ST.MICHAEL'S Manchester
Supplementary Design Report

July 2023

This report is intended to illustrate the differences between the consented development scheme and the latest proposed design iteration. The proposed design incorporates changes concerning the refinement and evolution of the consented design in response to concerns of environmental, practical, and cultural changes that have occurred through the course of the project.

Key Changes

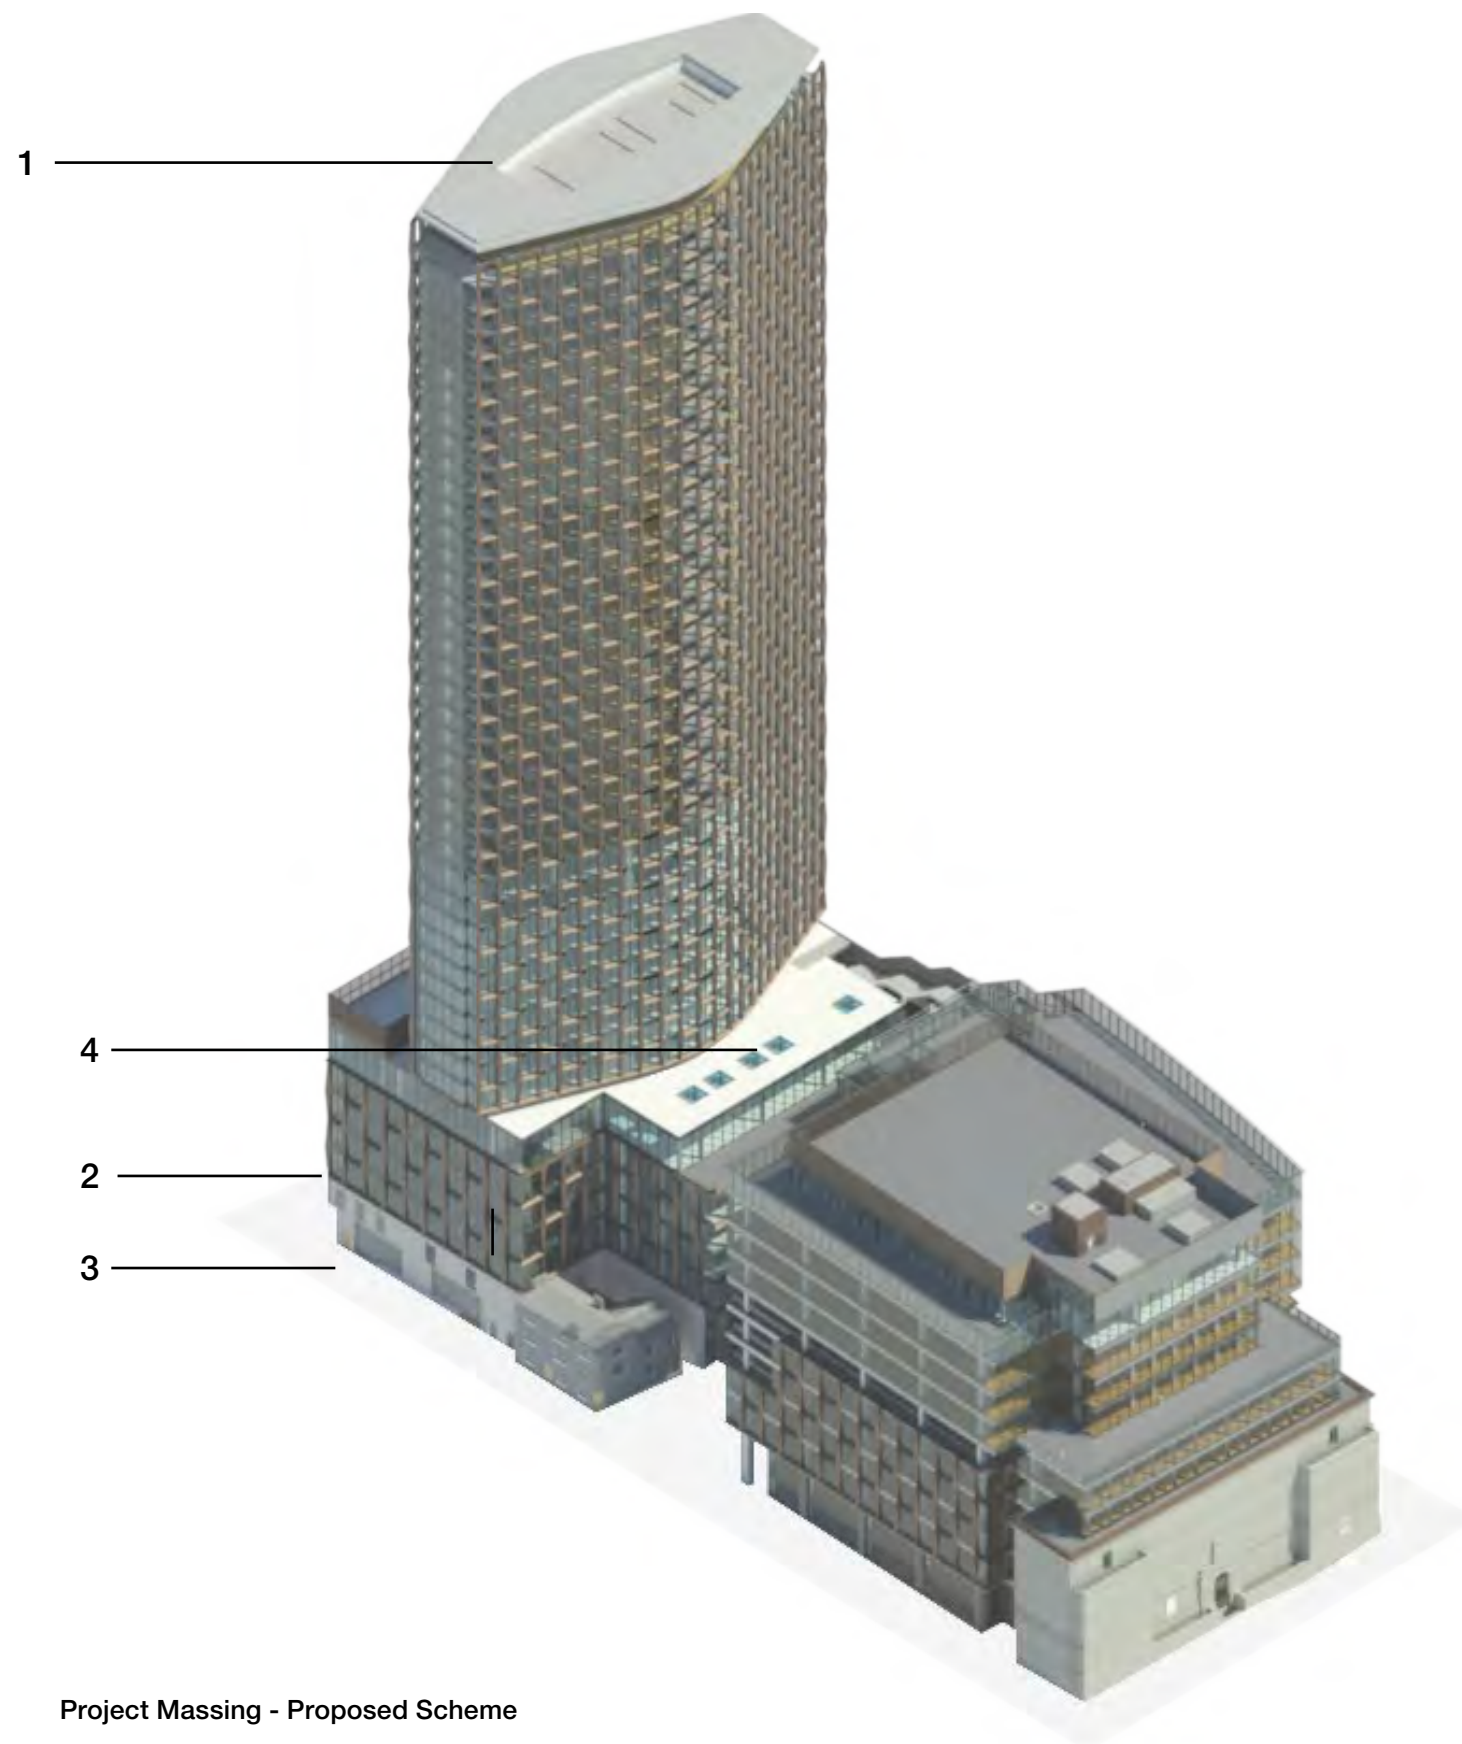
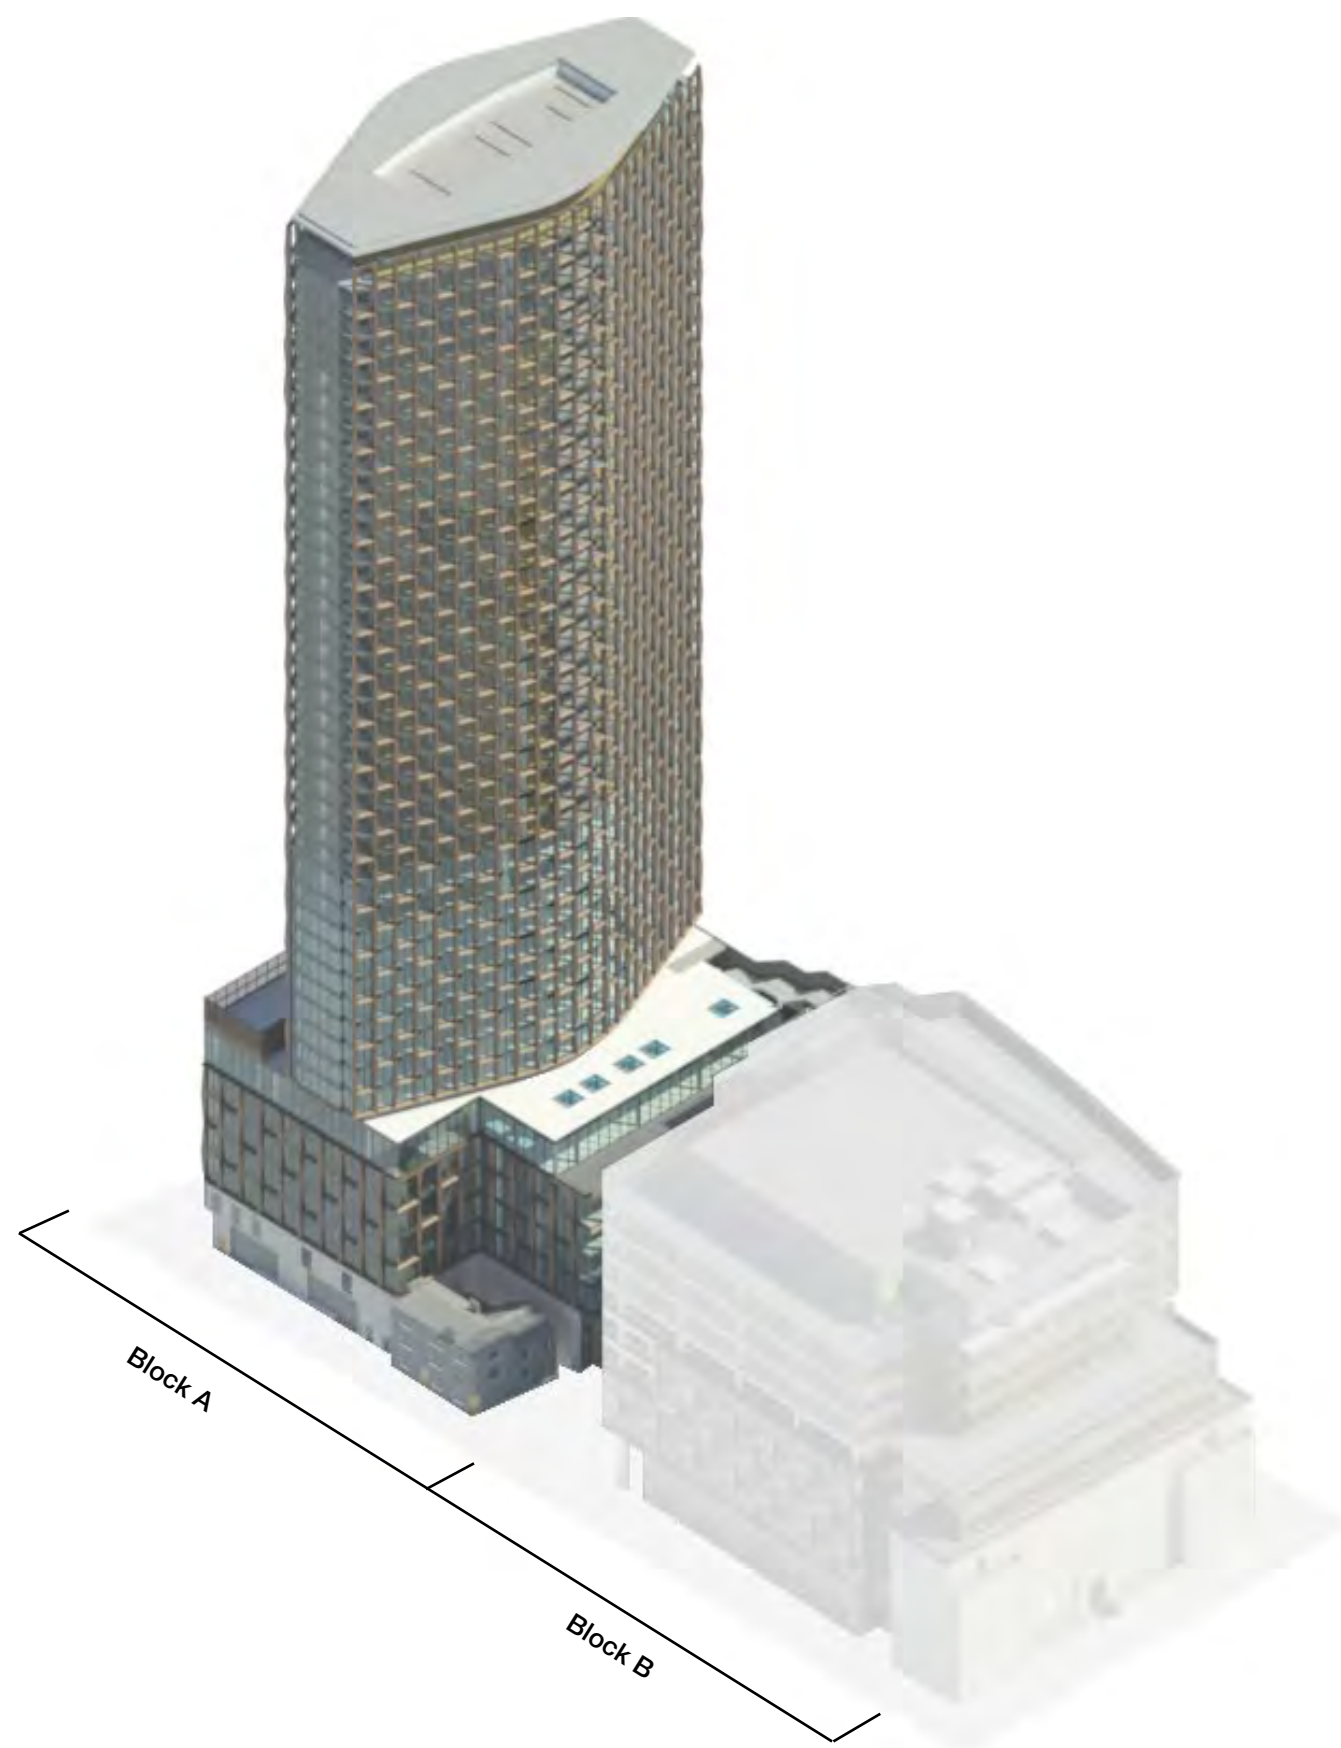
- + **1.** The addition of 2 storeys of residential apartments, increasing the height of the tower by 7m
- + **2.** Reconfiguration of ground floor, basement level 01 to accommodate the changes in cycle and residential bin provision.
- + **3.** Amendment of Basement Level 02 internal layout as part of detailed design.
- + **4.** Amendment of Level 06 internal layout as part of detailed design.

Basement Level -02

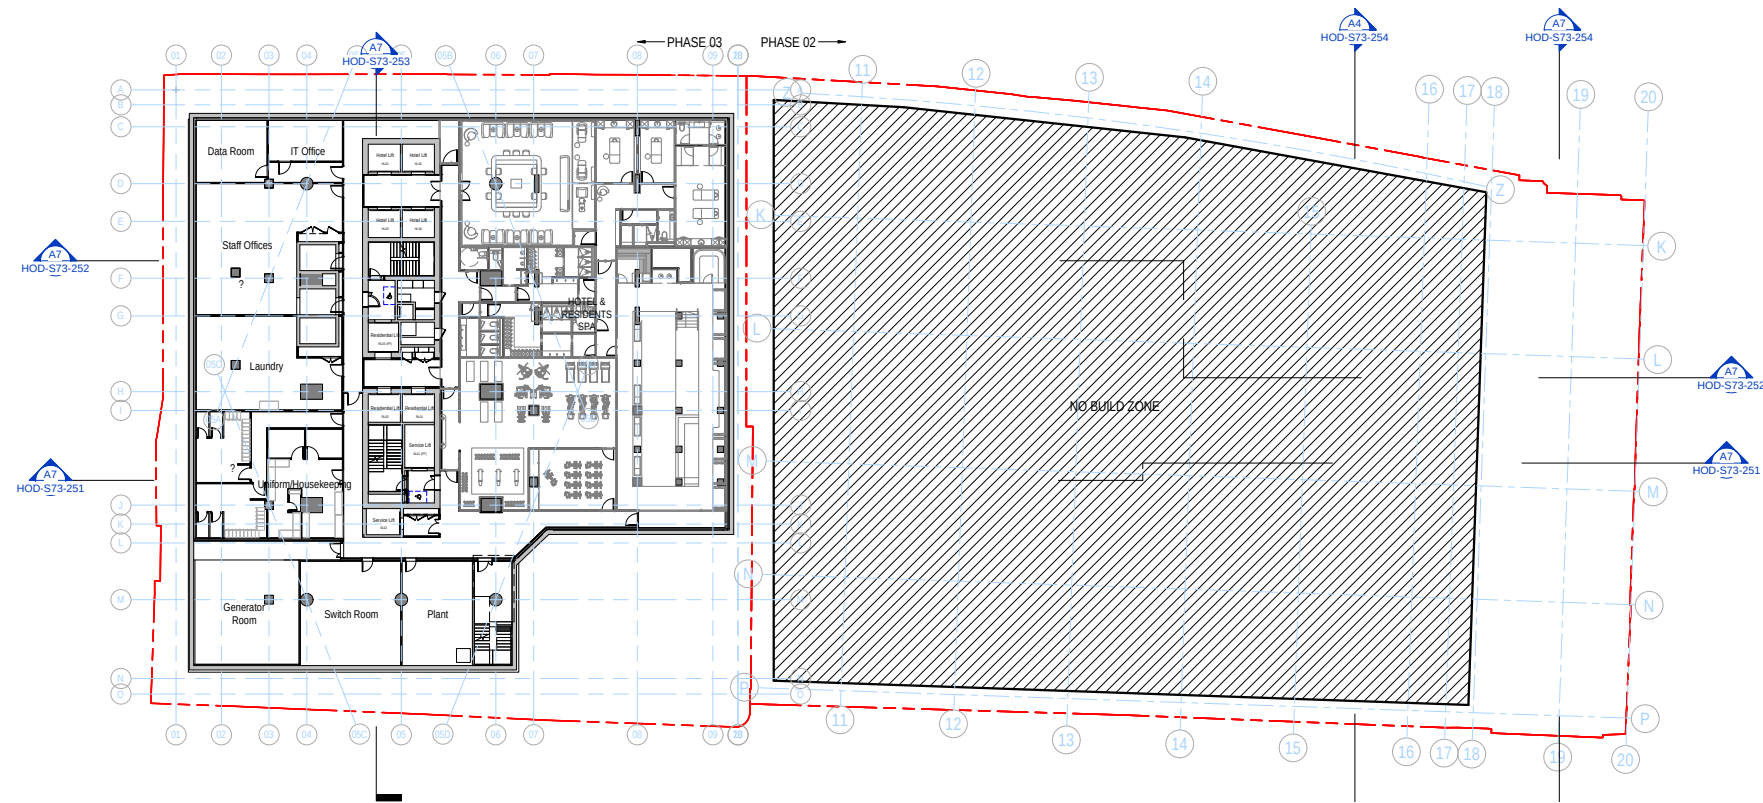
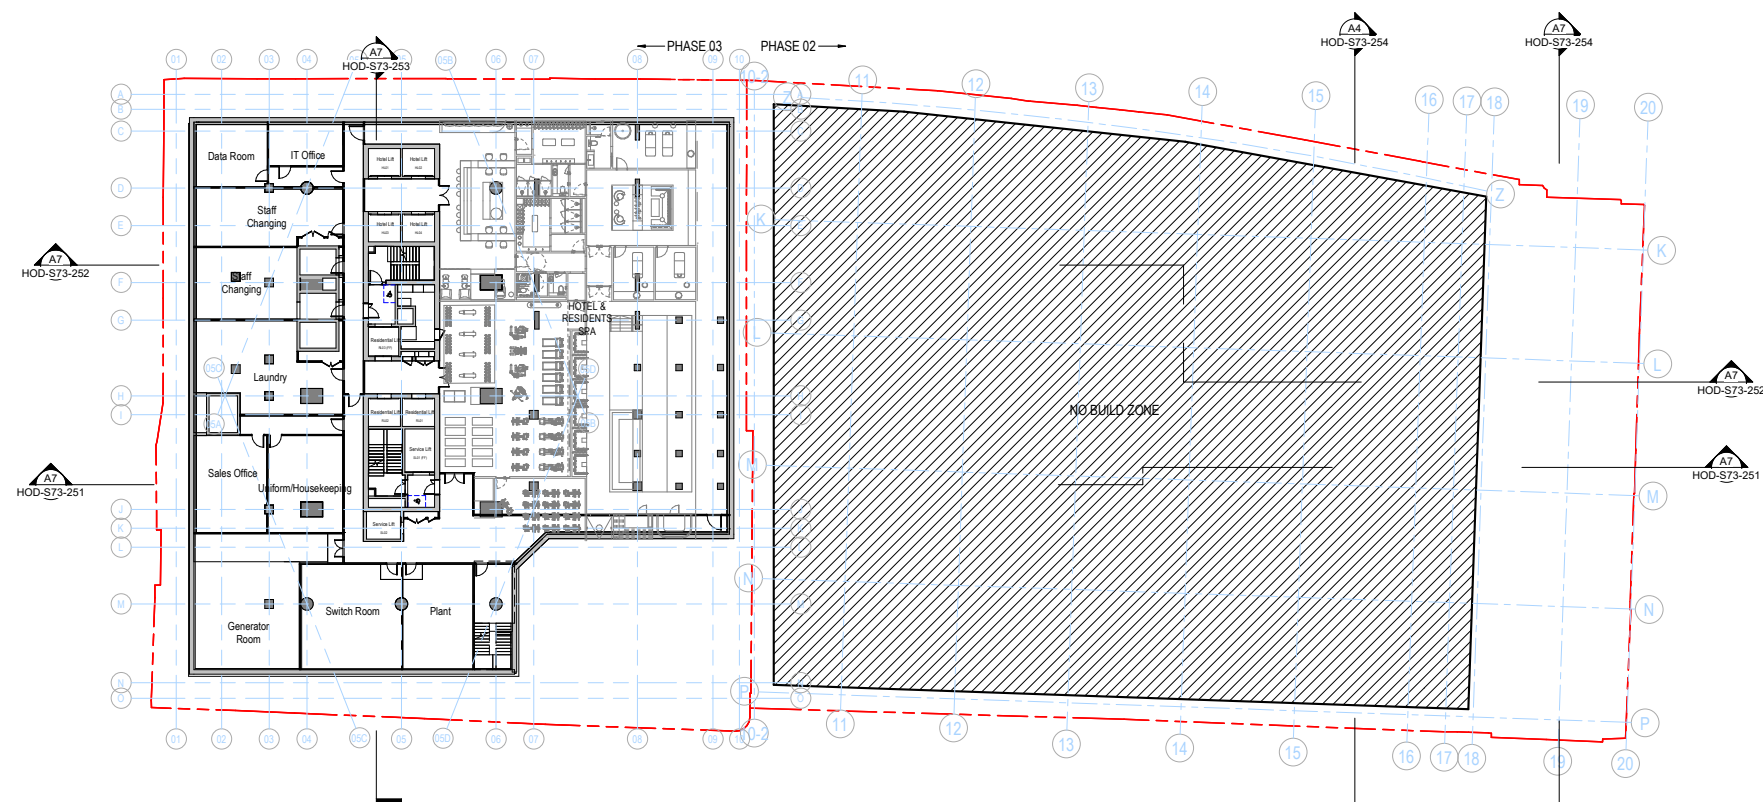
There has been reconfiguration of the internal layout as part of detailed design development with the client.

Basement Level -01

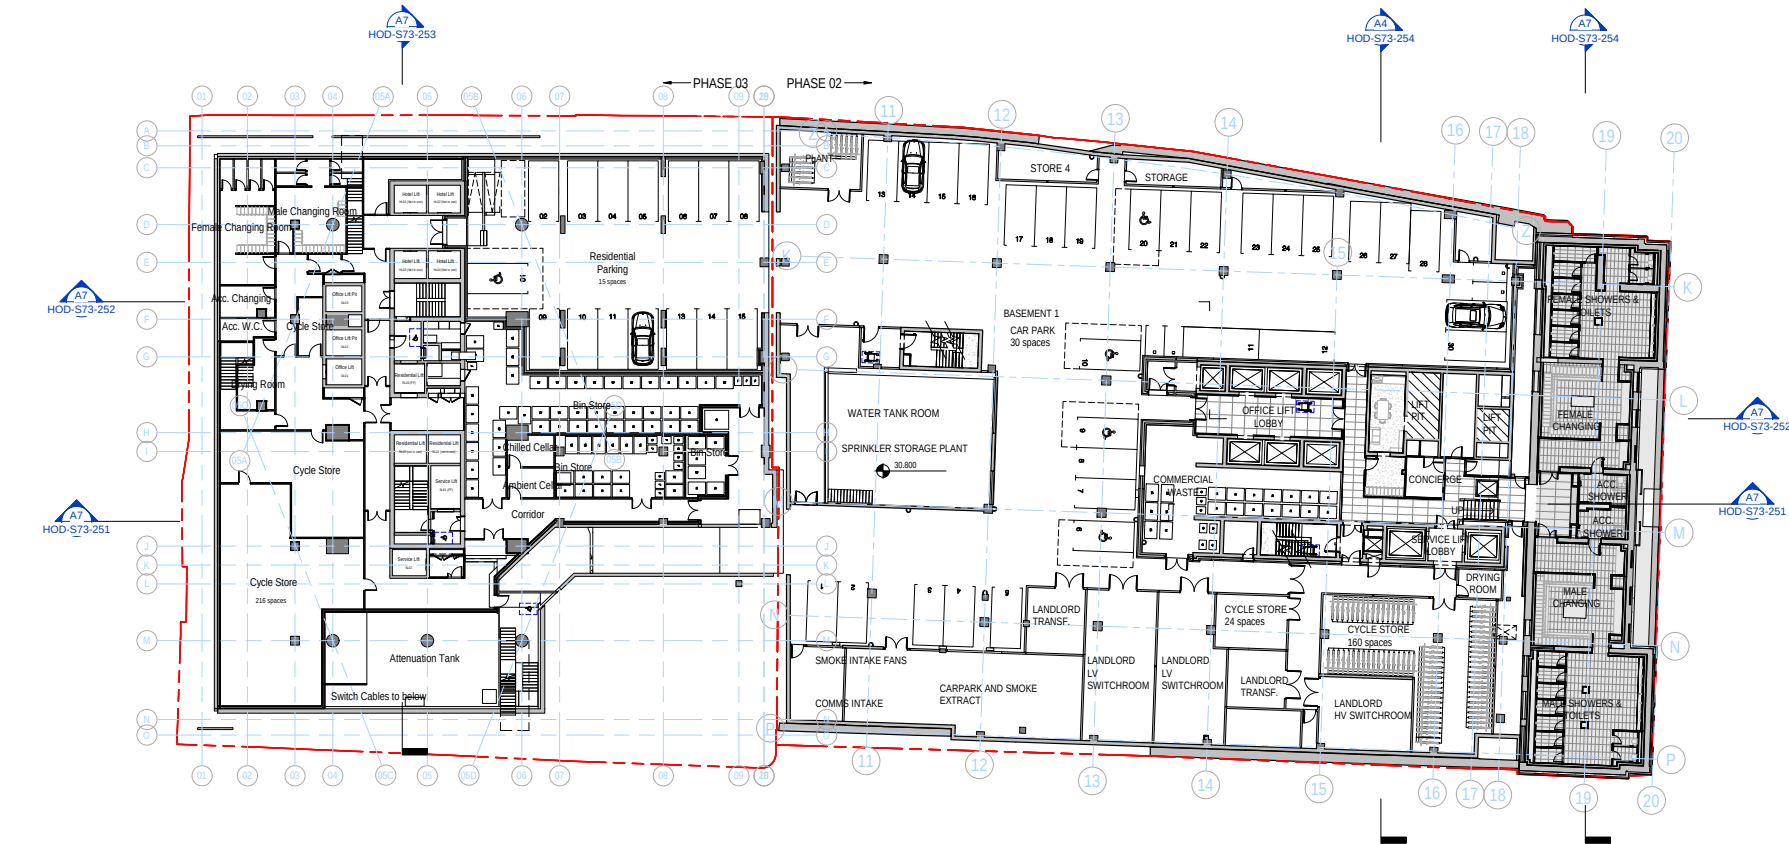
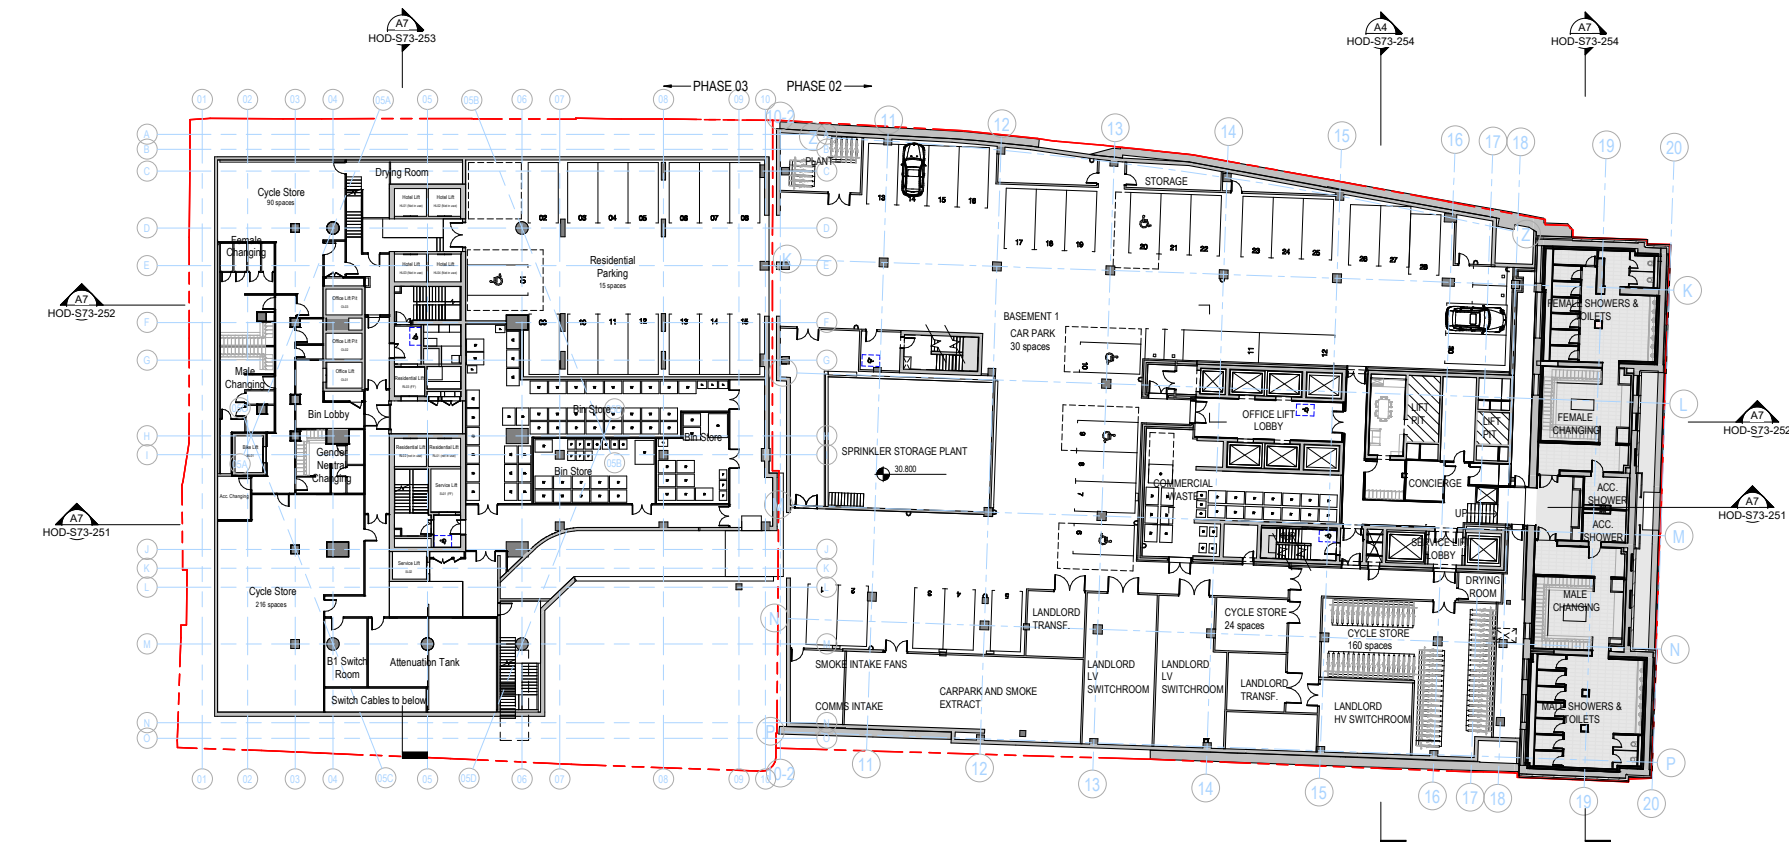
The main basement level has been reconfigured to allow for the changes in cycle and bin provision. Cyclists can access the cycle stores via dedicated entrances with wider corridors for ease. In Block A, the cycle lift has been omitted and stores will now be accessed from Bootle Street via a bicycle stair ramp located in Stair 03. Disabled and scooter access to the stores will be made separately, via lifts as outlined in the Building Management Plan. For Block B, access remains the same with the cycle store accessed via the service lift from Bootle Street.

Cycle spaces have increased to a total of 521 in line with the additional apartments.
